Quietway 7 – Elephant & Castle to Crystal Palace Consultation

London Borough of Lambeth – Gipsy Hill area
Response to consultation
10 February to 20 March 2016
June 2017

Parallel zebra and cycle crossing proposed at Paxton Place/Gipsy Road

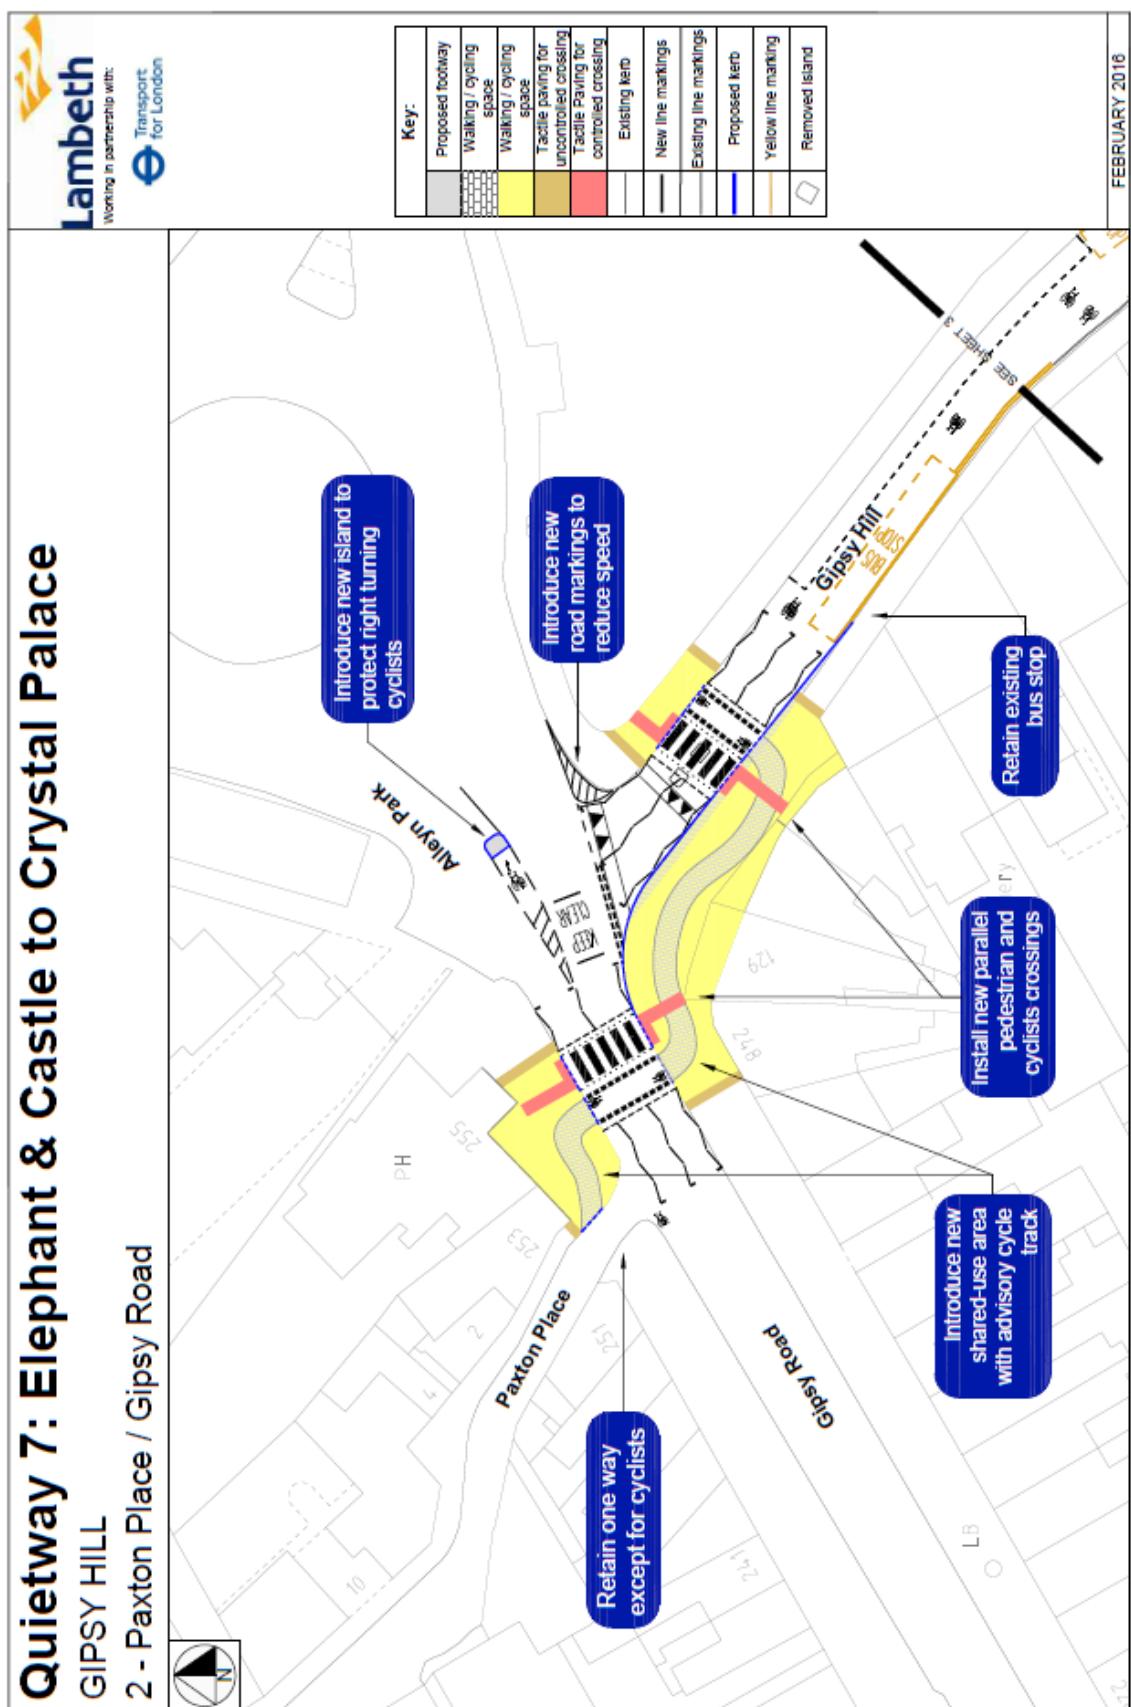
Four comments made various concerns regarding the parallel crossing as part of the proposals. One respondent made more than one remark.

- One comment stated that the crossing would pose a danger to pedestrians, as they would be competing with cyclists for space
- One comment stated that the crossing was potentially dangerous as vehicle drivers would have to observe both cyclists and pedestrians
- One comment suggested that there might be confusion as to which mode has priority at the crossing

- One comment stated that the crossing would be too complicated and slow for cyclists, therefore it might be ignored
- One comment stated that the crossing might not be needed due to the presence of the right turn waiting area on Gipsy Road.

The parallel zebra crossing is a recent addition to the Traffic Signs Regulations and General Directions (TSRGD) manual that allows cyclists to cross a road separate from pedestrians to reduce conflict points. The crossing is an effective traffic calming measure as well an efficient tool to provide a good crossing facility for vulnerable road users.

3 - Gipsy Hill

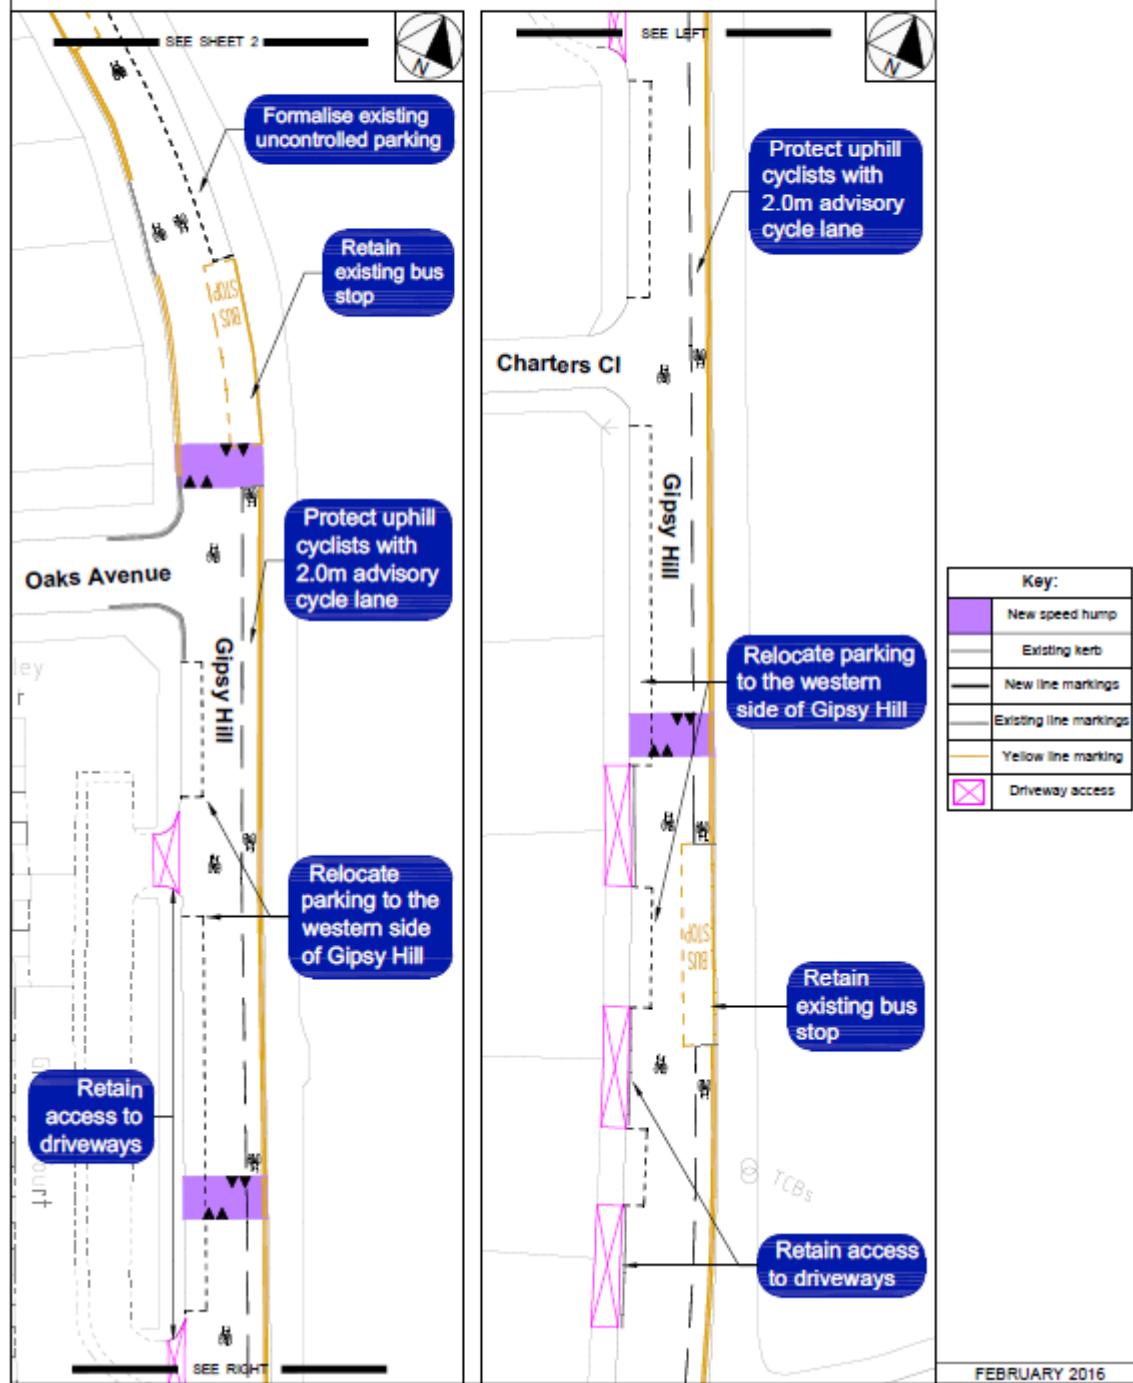
- Seven comments were concerned with the loss of parking from Gipsy Hill, including one comment stating that this would put additional stress on Oaks Avenue
- One comment stated that the loss of parking would make accessing residential properties off Gipsy Hill more difficult

- Four comments suggested that the proposed relocation of parking would reduce visibility for vehicles exiting residential properties on Gipsy Hill
- Four comments suggested that relocation of parking would encourage higher vehicle speeds along Gipsy Hill
- Two comments stated that the proposed relocation would increase the risk of dooring for cyclists travelling towards Gipsy Road
- One comment suggested that the relocation of parking would make access to residential properties more difficult
- One comment stated that relocating a parking bay opposite the bus stop on Gipsy Hill introduced a dangerous pinch point

- Five comments stated that the vehicle speeds are high on Gipsy Hill, despite the low speed limit
- Three comments stated that there needed to be greater intervention to reduce vehicle speeds on Gipsy Hill
- One comment stated that more signage might be needed to alert drivers of the existing speed limit

- Three comments suggested that the advisory cycle lane would be used by motorists
- One comment stated that advisory cycle lanes were unsuitable for this application
